MICHAEL DRISCOLL SCHOOL

OPM Monthly Project Update Report

January 2022

Change Order #8 Summary

Re: Matt Slab Dowel Reinforcement

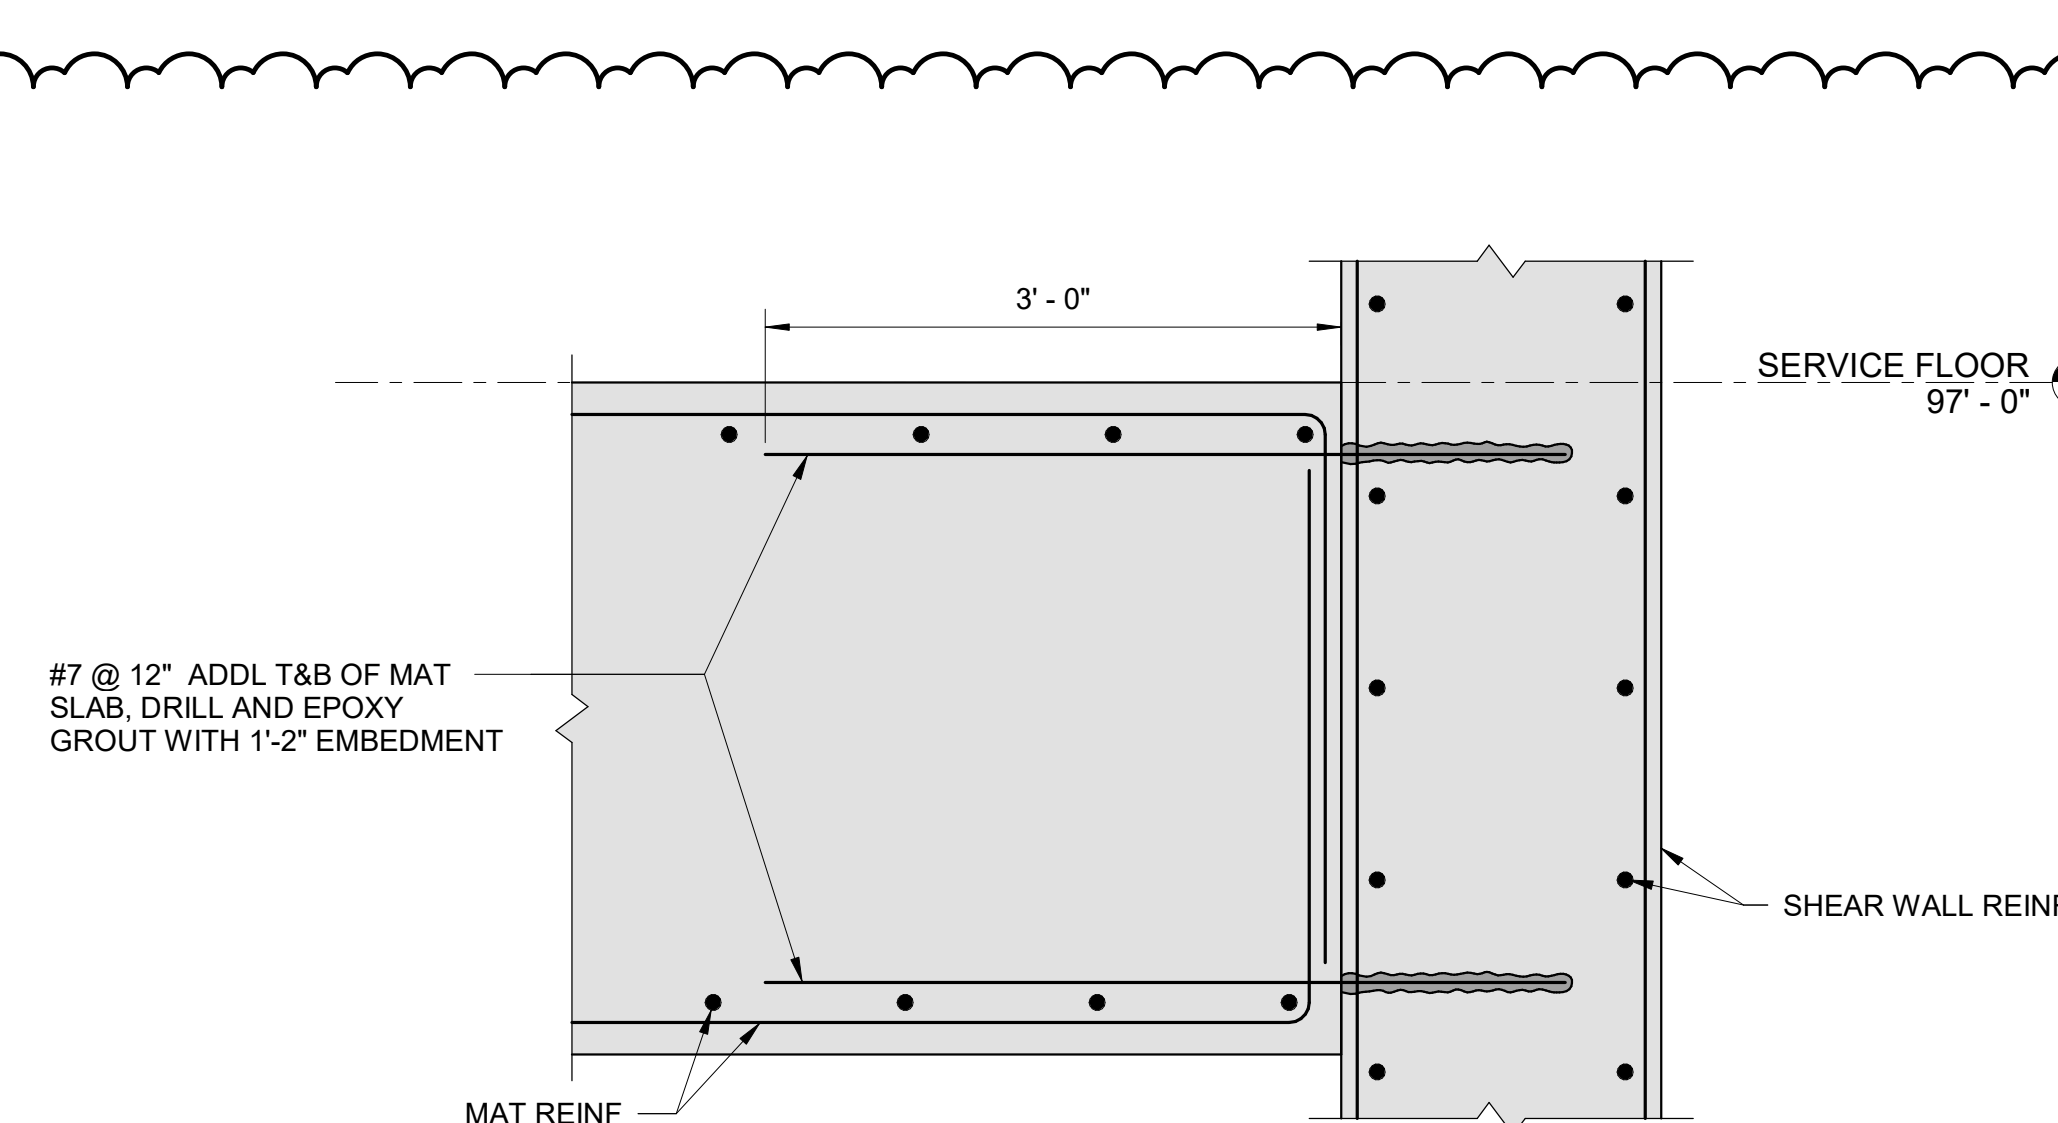
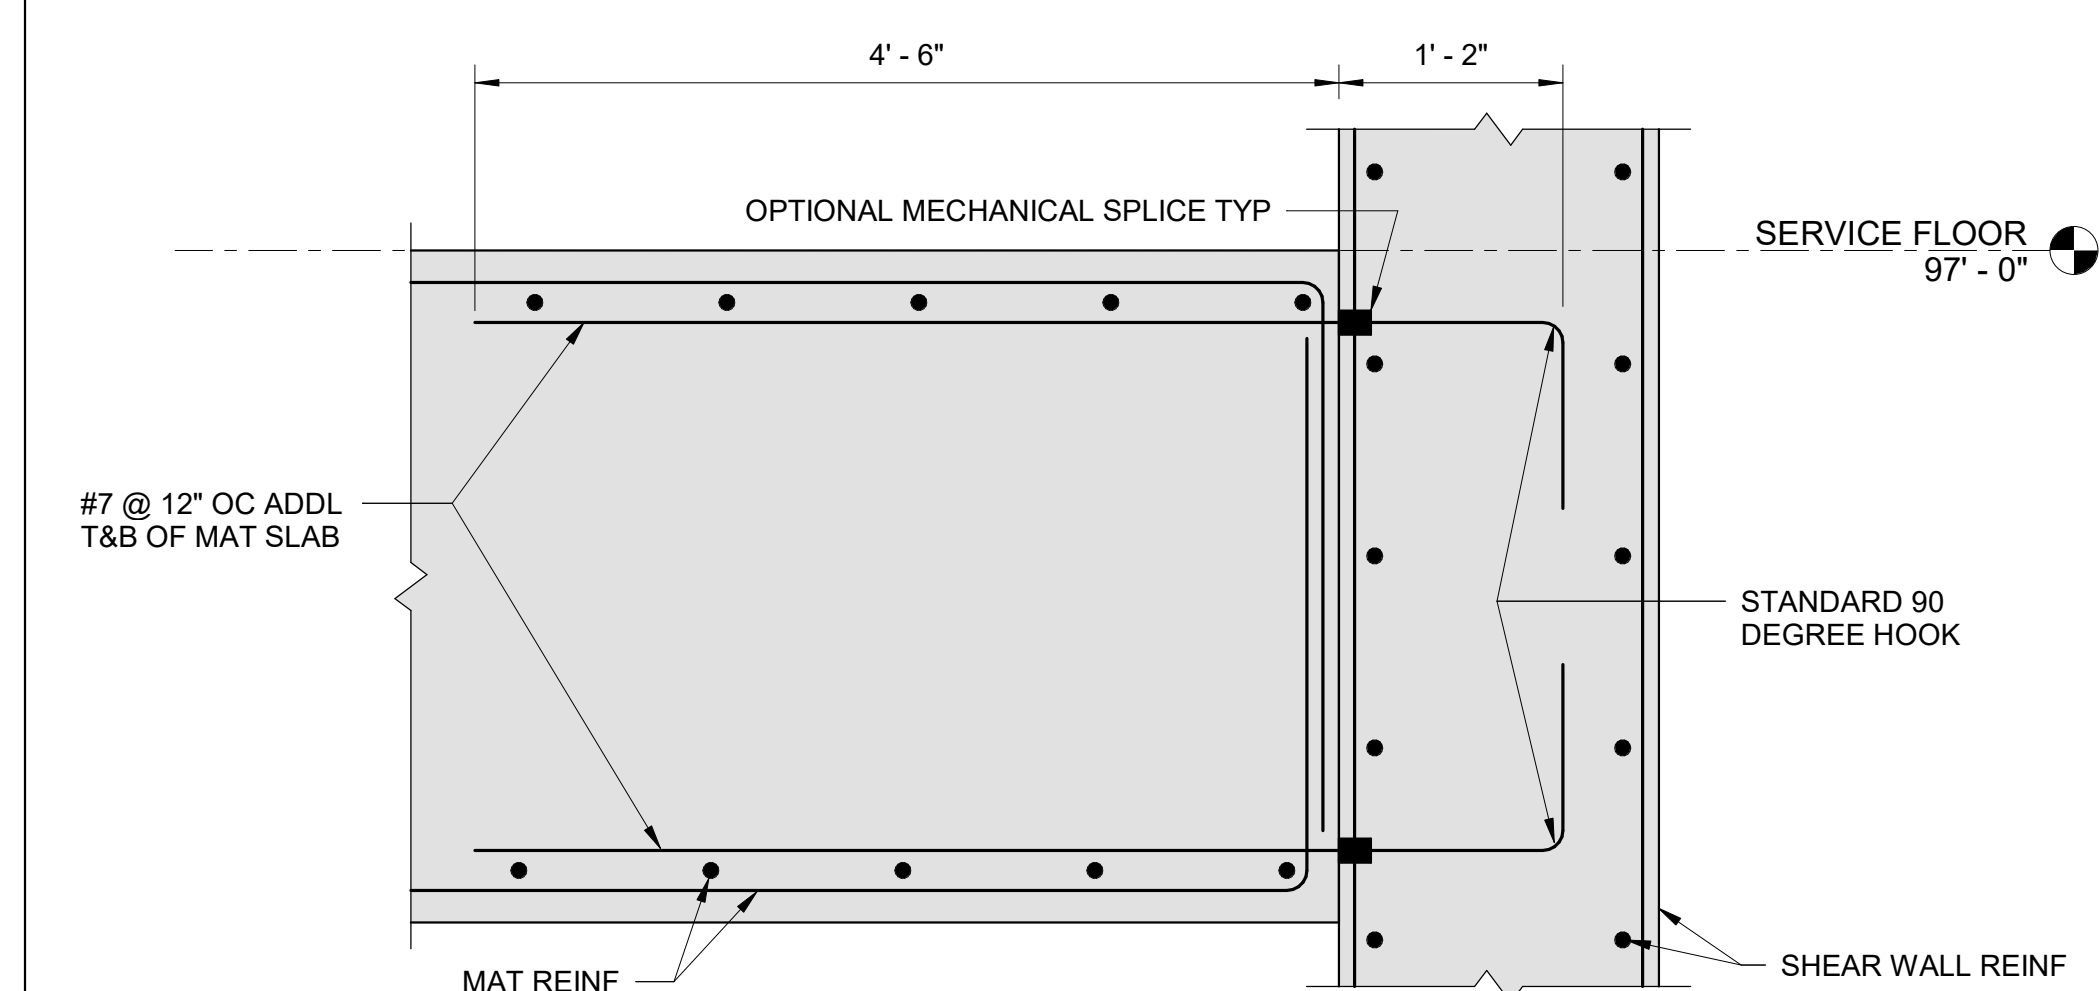
7 MAT SLAB DOWELS TO ELEVATOR WALLS
SCALE: 1" = 1'-0"

8 MAT SLAB DOWELS TO FOUNDATION WALLS
SCALE: 1" = 1'-0"
